File No: SP 23-01 & PA 23-01 Site Development Review and Partition for Pure Energy Group

Summary: On May 2, 2023 the Millersburg Planning Commission held a public hearing for the project. The Commission approved the Site Development Review and Partition applications with the conditions of approval listed in the staff report. The Commission found that all criteria and standards were met based on the accepted facts and the conditions of approval. The Commission relied on facts from the staff report, the applicant's materials, and the City's Comprehensive Plan, Codes, and Ordinances as provisions for the basis of their decision. No changes were made to the proposed conditions of approval and no additional conditions were added.

Proposal: The applicant is proposing concurrent review of a Tentative Partition for a two lot split, one parcel is proposed to be 4.50 acres and the second parcel is proposed to be 1.25 acres, and a Site Development Review for a new 7,480-square-foot building for a solar sales and installation facility that will include an office, showroom open to the public, warehouse/ storage space and 15 parking spaces with landscaping.

PRELIMINARY CIVIL SITE PLAN
PURE ENERGY GROUP
TAX LOT 1200, MAP 10S-3W-21D
MILLERSBURG, OREGON

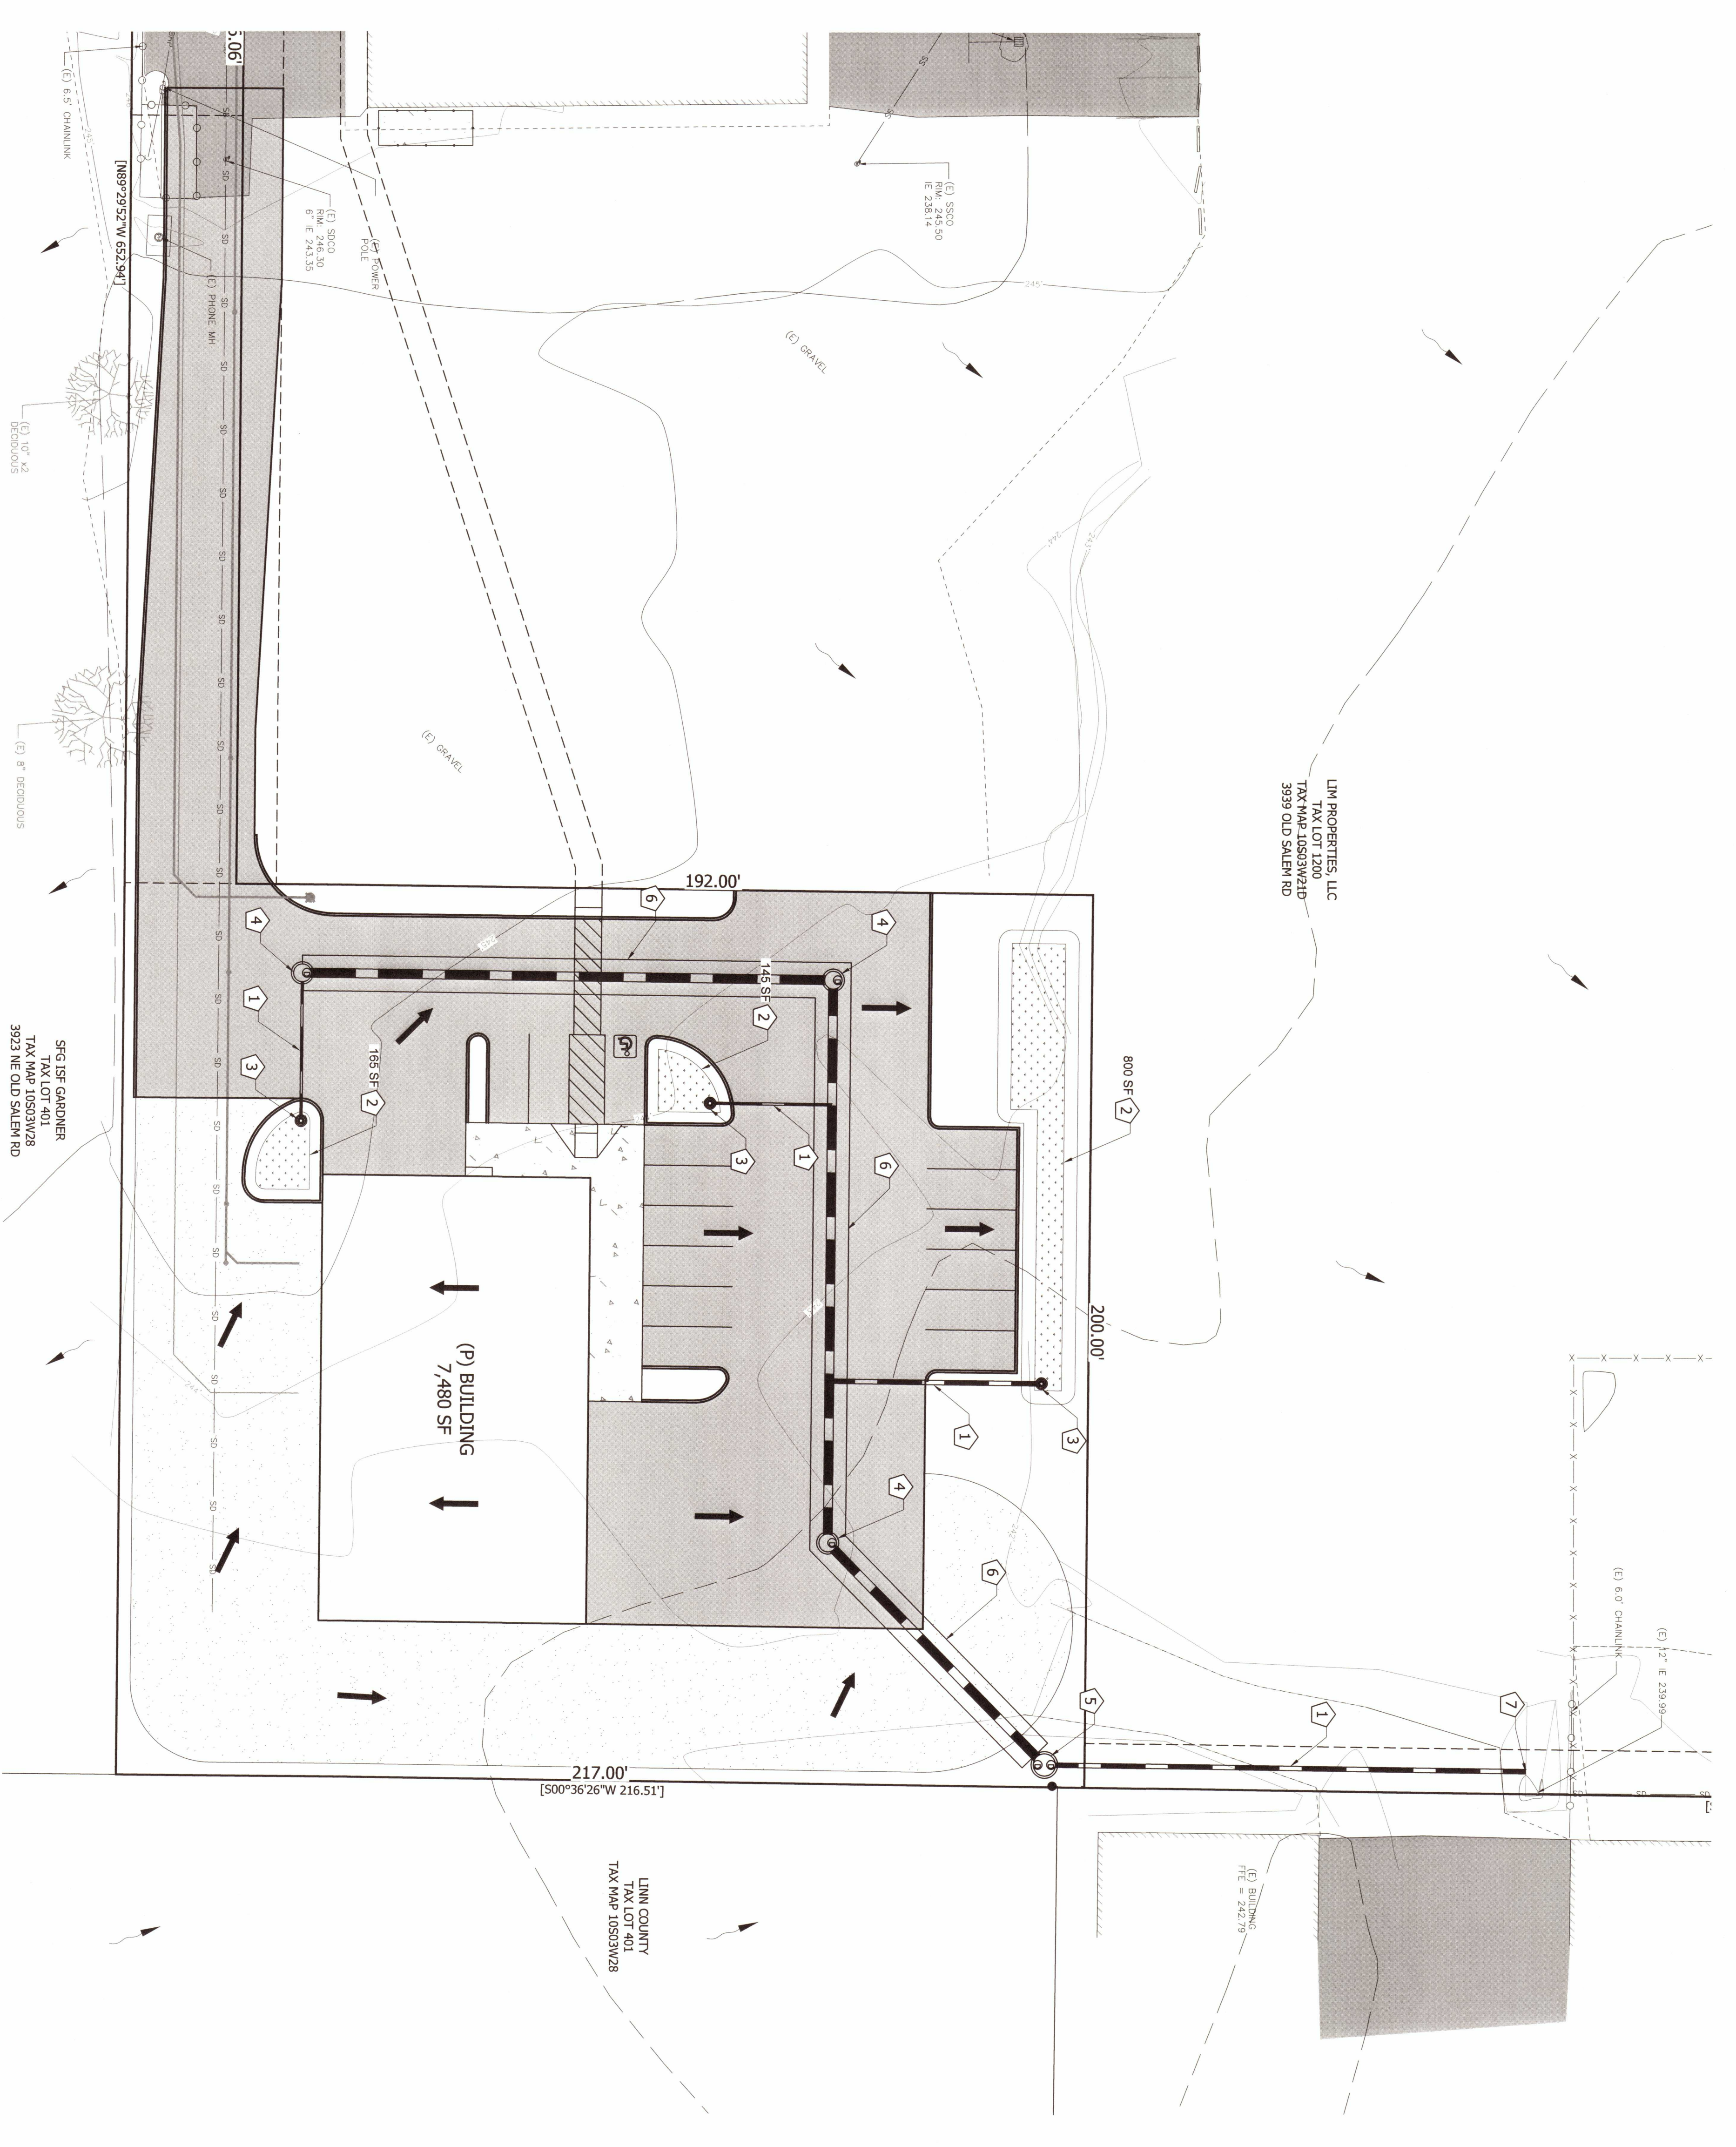
The gravel areas to the south and east of the proposed structure are not proposed for outdoor storage, therefore no outdoor storage of any kind is permitted in these areas. The areas could be used for future outdoor storage with a site development review, and fencing added to comply with 2.08.060(6). Additionally, the lot coverage requirements would remain in effect. This has been added as a condition of approval.

that spans the west side of Parcel 2. The Code specifies that large boulders or other acceptable means be used to protect a car from entering into these landscaped areas. A condition of approval has been added to address this. Detailed landscape plans are required.

ANALYSIS: The site plan does not show any plaza area. Based on the size of the structure proposed, which is 7,480 square feet, the plaza area should be at least 70 square feet. A condition of approval has been added requiring the applicant to add a plaza to the site plan for the project. Because the location and design of the required plaza could be a discretionary interpretation, the Planning Commission may require these to be submitted prior to approving the project.

- o Prior to issuance of a building permit, the applicant shall redesign the site plan to add a plaza that is at least 70 square feet and meets the requirements of 3.26.030(8), to the satisfaction of the Community Development Director.

GRADING AND DRAINAGE PLAN
 PURE ENERGY GROUP
 TAX LOT 1200, MAP 10S-3W-21D
 MILLERSBURG, OREGON

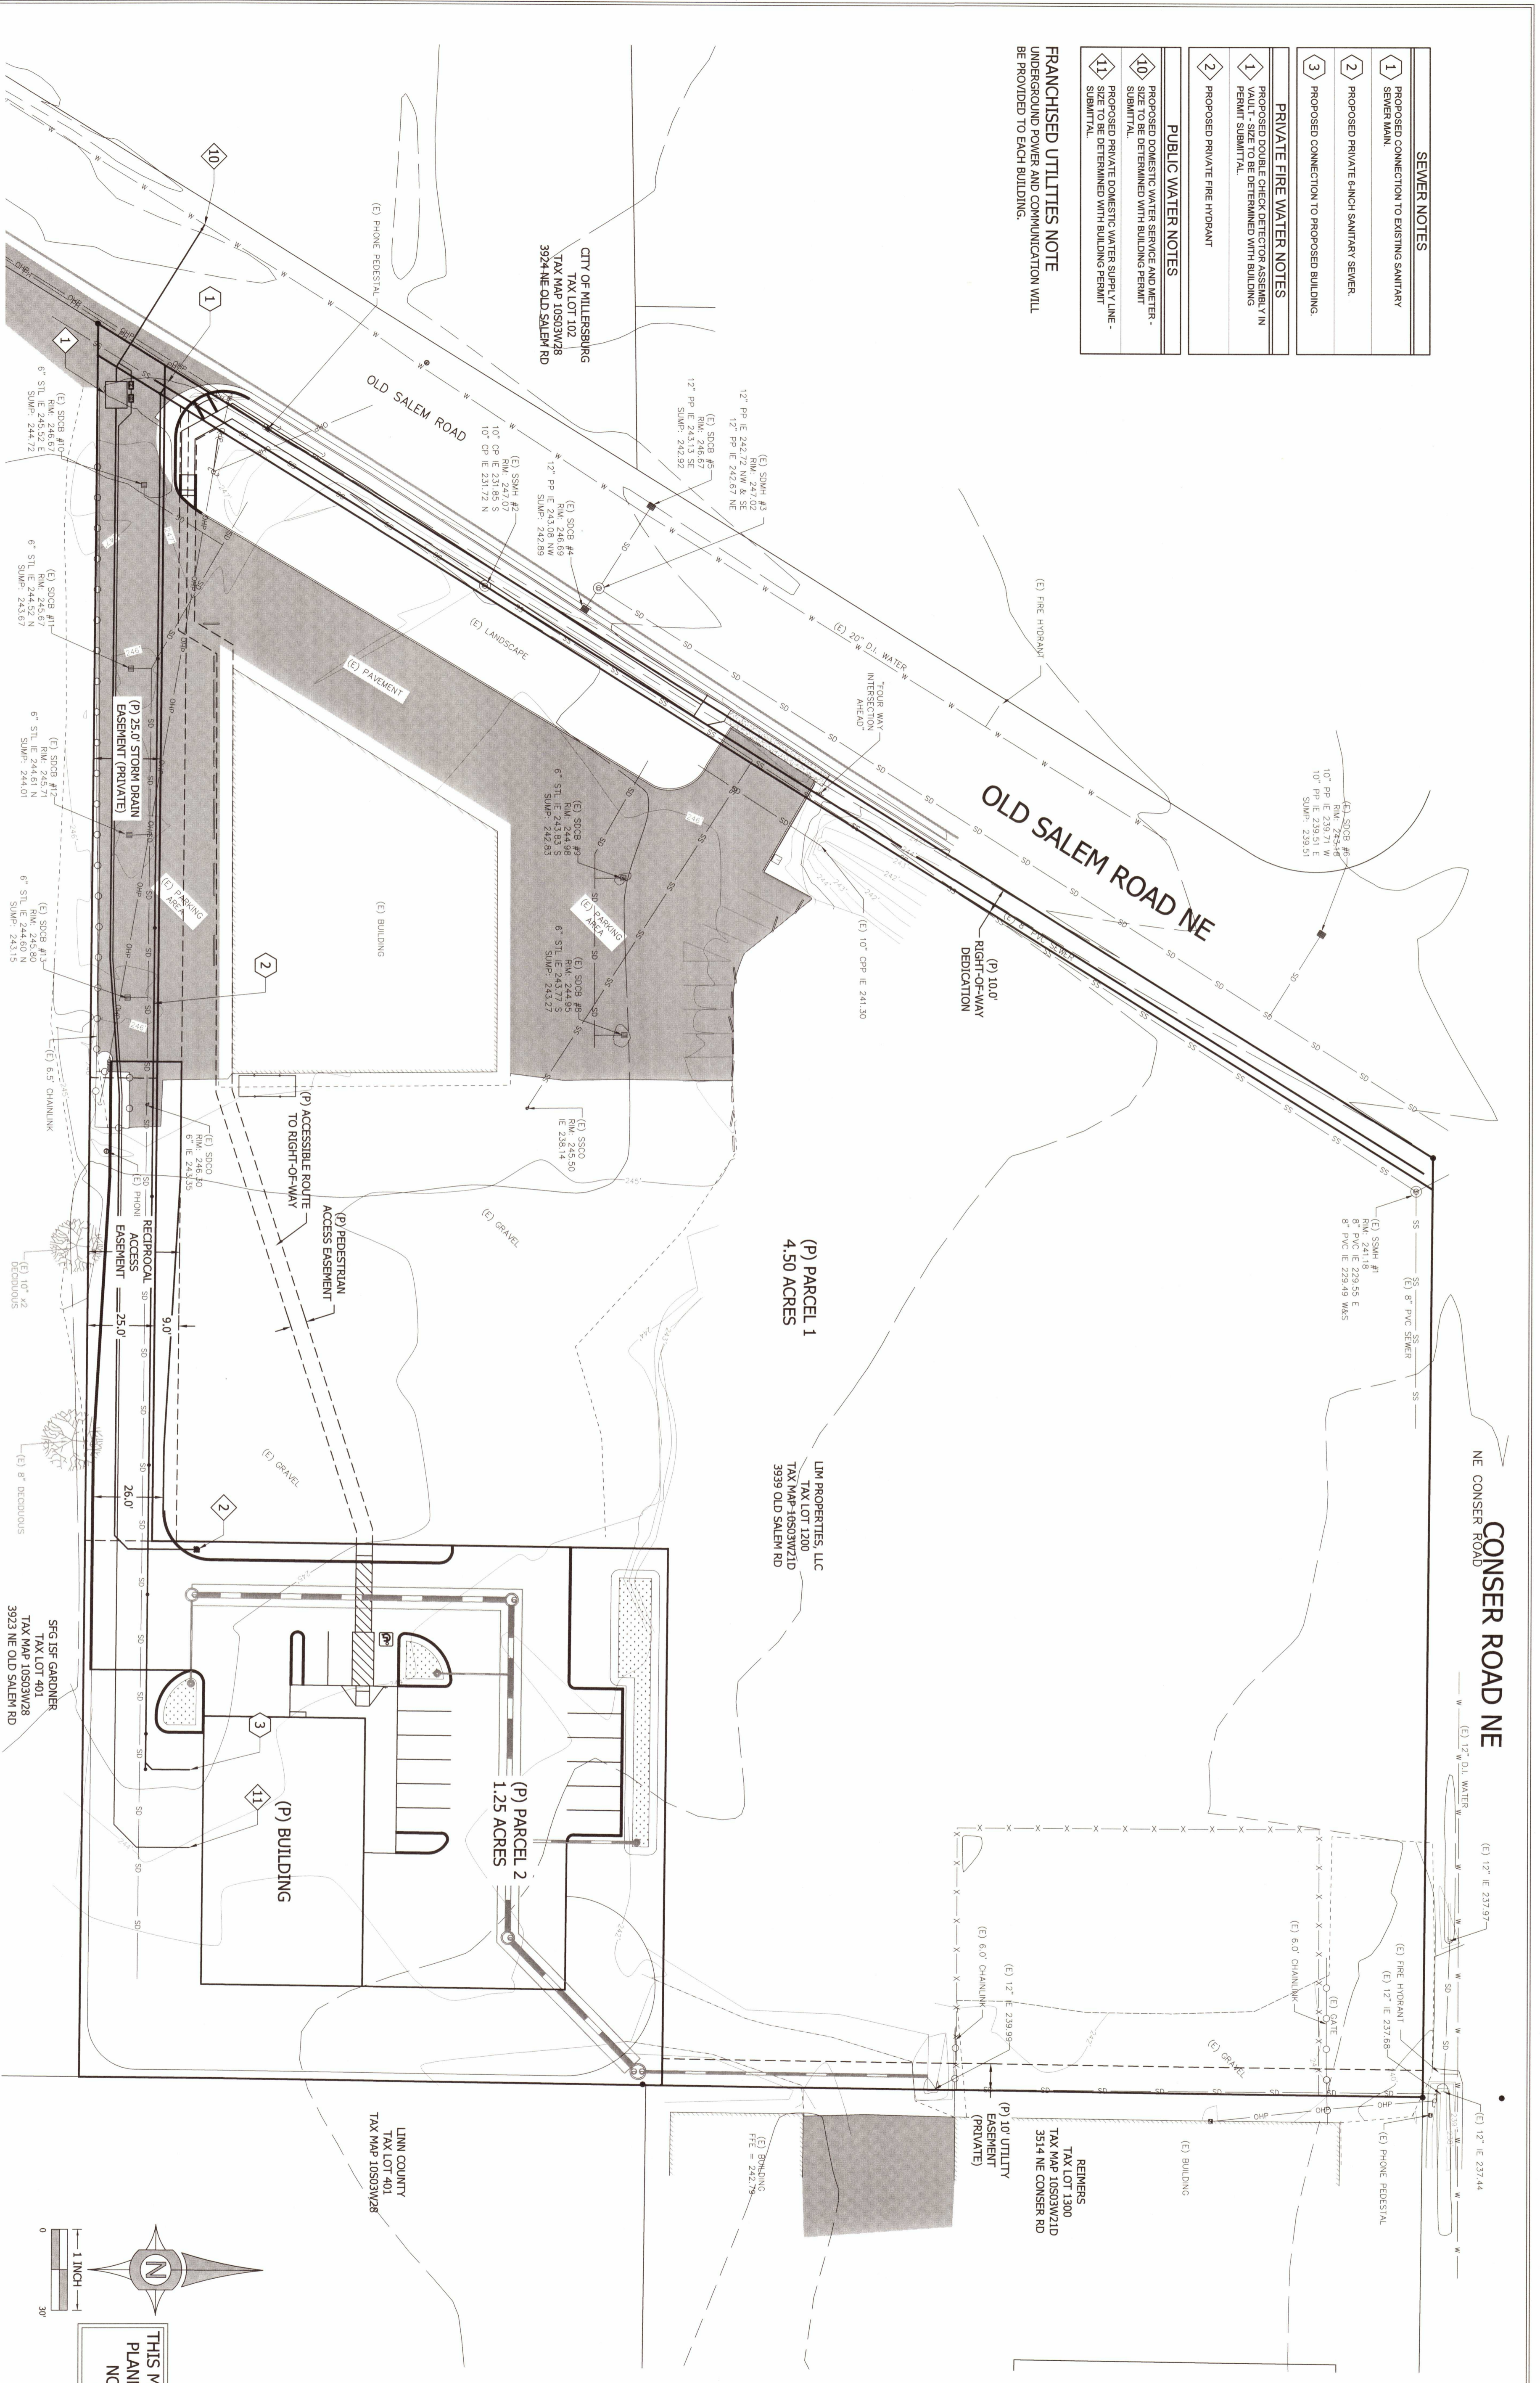
ANALYSIS: All development in the City is required to provide for storm drainage. A partition is considered development. The applicant did provide details regarding drainage, however additional details are required to show full compliance with the Code requirements. A final drainage plan will need to be submitted.

ANALYSIS: As outlined above, the applicant has not provided a final drainage study. A 1200-C permit and a Millersburg permit for temporary erosion protection during construction must be obtained by the contractor prior to any ground disturbing activities. Conditions of approval have been added to assure development matches the requirement of the Code.

Drainage. The applicant has been conditioned to provide a final drainage study prior to the map recording. Full construction of any identified improvements will be required prior to the map recording.

1
A3
NTS
ELEVATION NORTH VIEW

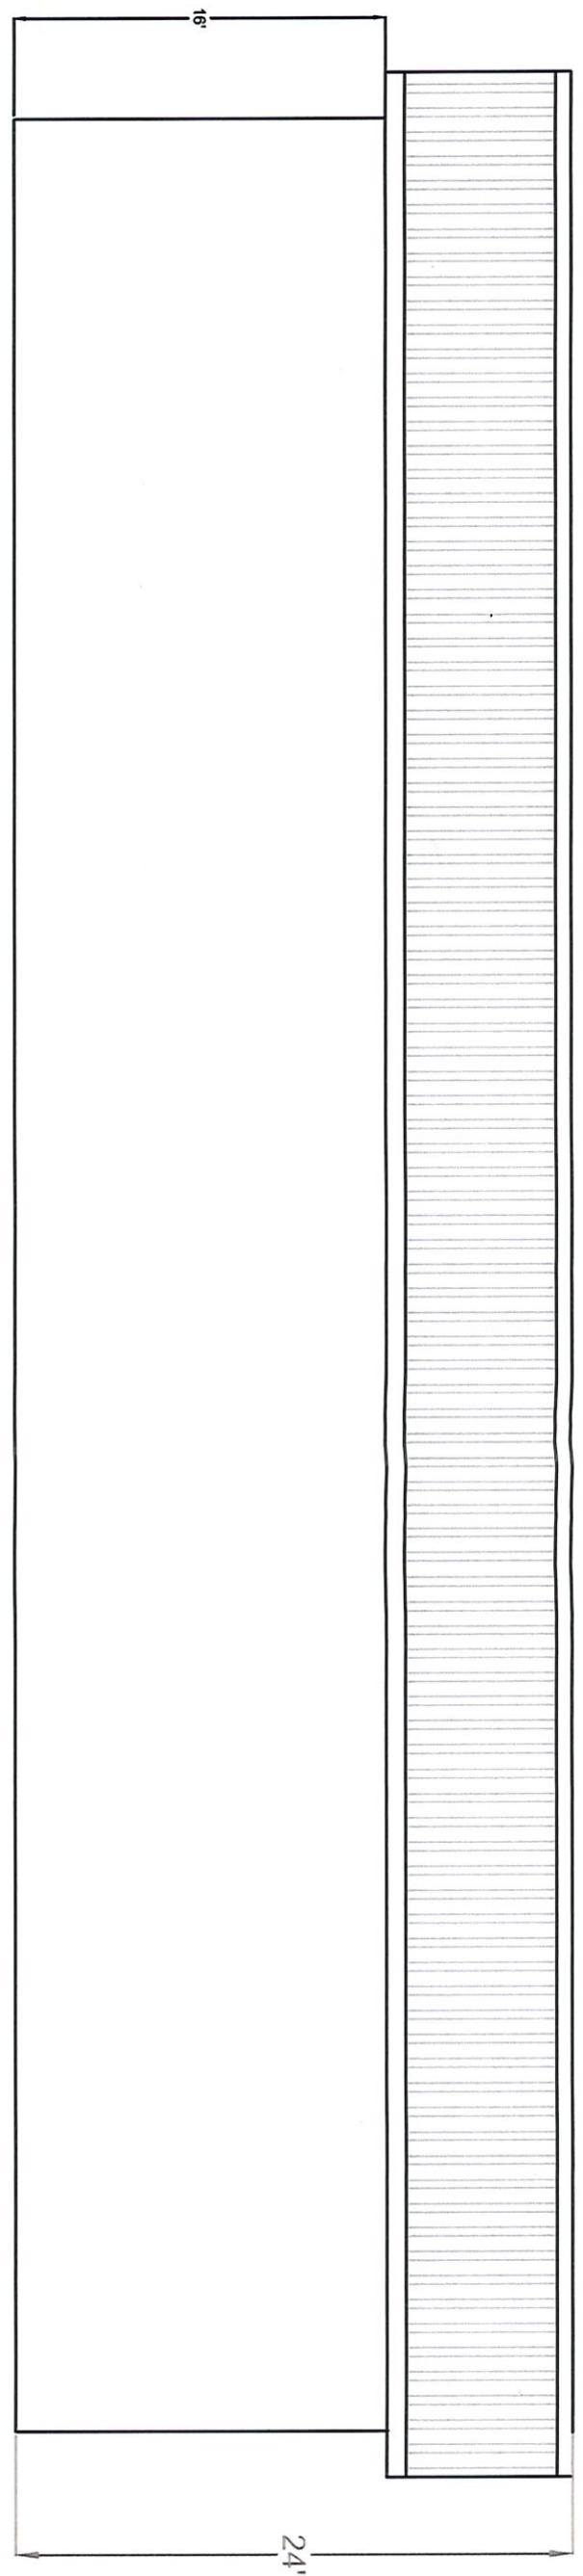
The west and north facing walls are visible from the street and therefore apply. The elevations show compliance with the windows requirements. The applicant's narrative explains that a 2/12 roof pitch and combinations of wall finishes show compliance. Covered awnings are included as well. The Code further requires that at least 50% of the walls length include architectural features and landscaping. As submitted, the west wall meets this requirement, the north wall does not appear to meet the requirement. It seems all architectural features cover only about 40% of the wall length. Additionally, it is not clear if the landscaping will cover 50% of the wall length because landscape plans were not provided. Conditions of approval have been added. Because this requirement may be a discretionary interpretation, the Planning Commission may require these to be submitted prior to approving the project.

- Prior to building permit issuance, the building plans for the north façade shall be revised to include architectural features along at least 50% of the wall length, to the satisfaction of the Community Development Director.
- The north and west facing wall of the structure shall include landscaping along the façade of the structure for at least 50% of the wall length (abutting the building), to the satisfaction of the Community Development Director.

15. Prior to building permit issuance, the building plans for the north façade shall be revised to include architectural features along at least 50% of the wall length, to the satisfaction of the Community Development Director.
